**ALERT SERVICE BULLETIN**

**SUBJECT: REVISION "B" TO ALERT SERVICE BULLETIN 205B-00-30: (MAIN ROTOR MAST 204-011-450-007/-105 INSPECTION AND RETIREMENT INDEX NUMBER RIN REDUCTION)**

NO. 205B-00-30

**SUBJECT:** MAIN ROTOR MAST, P/N 204-011-450-007/ -105, INSPECTION AND RETIREMENT INDEX NUMBER (RIN) LIFE REDUCTION

**Figure 1**

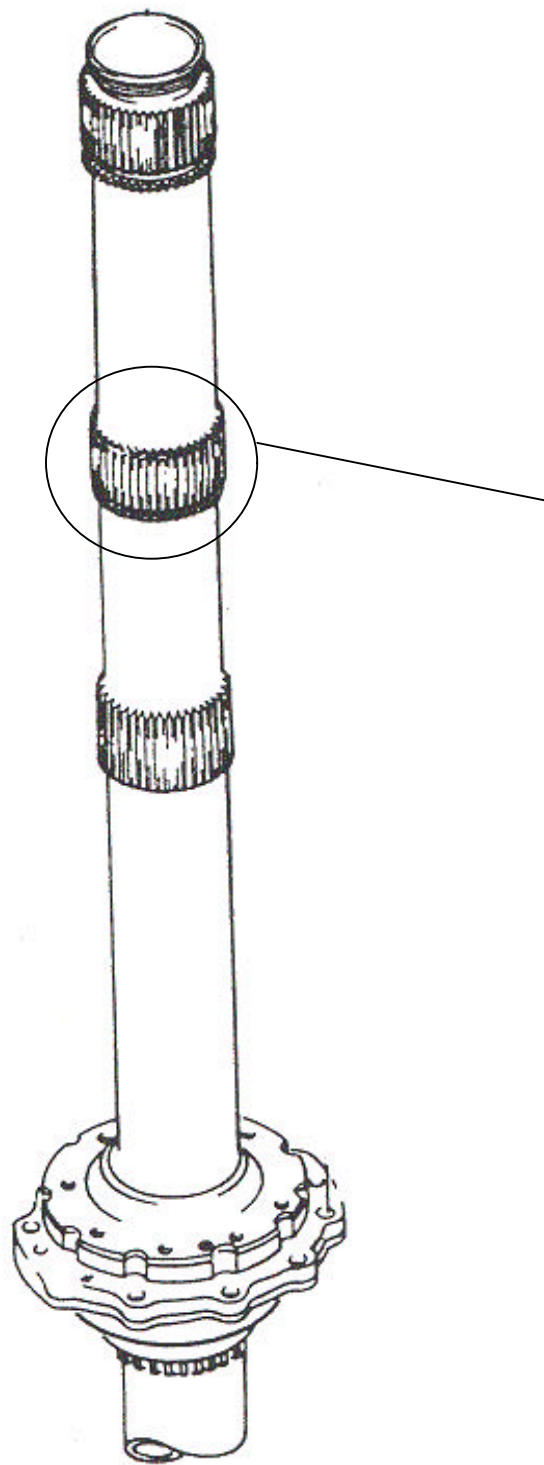
- 1. Inspect the mast snap ring upper and lower grooves (entire circumference) for a minimum radius of 0.020 (figure 2, and figure 3 view A-A). Any mast that has indications of a radius less than 0.020 shall apply a 165,000 RIN penalty to the mast.
- 2. Inspect the mast snap ring upper and lower grooves for indications of burrs at all intersections with splines (see figure 3 view A-A, and figure 4). Any mast that has indications of a burr shall apply a 95,000 RIN penalty to the mast. Burr removal should not be accomplished.

**Inspect area for:**

- At 100X minimum magnification  
Minimum radius of 0.020 in the  
upper and lower snap ring groove,  
entire circumference
- At 200X minimum magnification  
Burr in the snap ring groove/spline  
intersection, all places

**FIGURE 3**  
Typical Burr at Snap Ring Groove

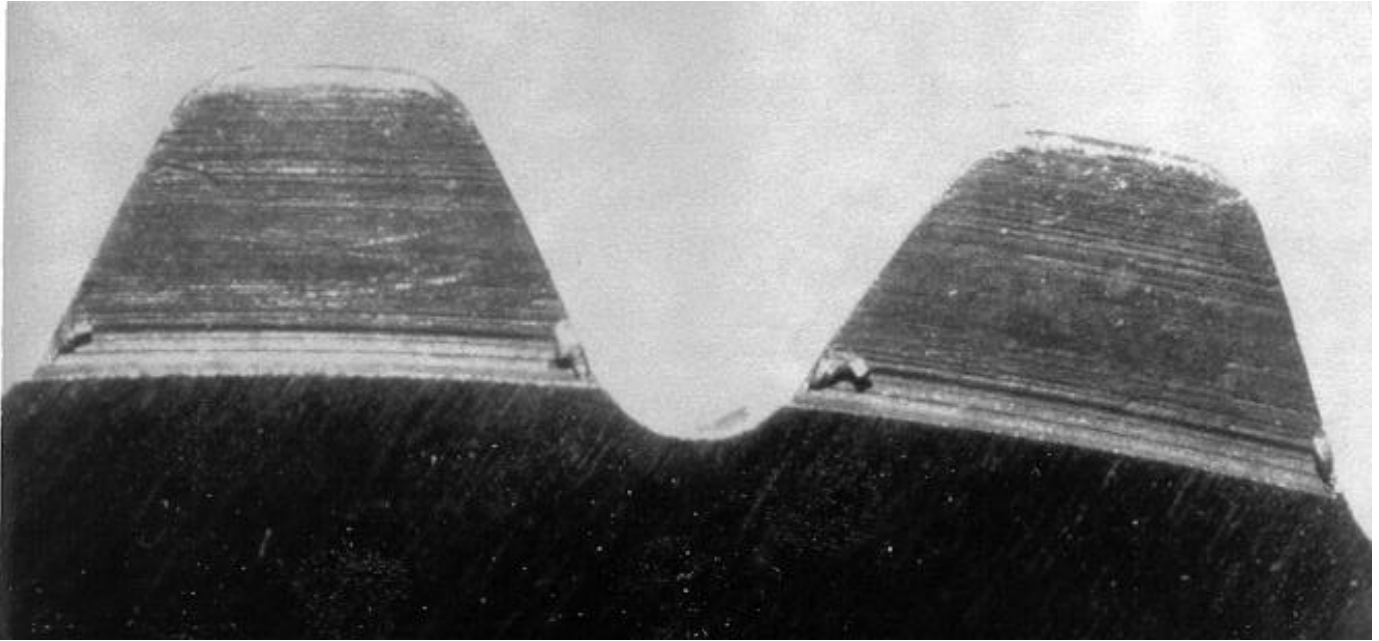
**Cutaway View looking down from inside snap ring groove**  
Typical burrs at snap ring groove/spline intersection  
Burrs are to be inspected at 200X minimum magnification
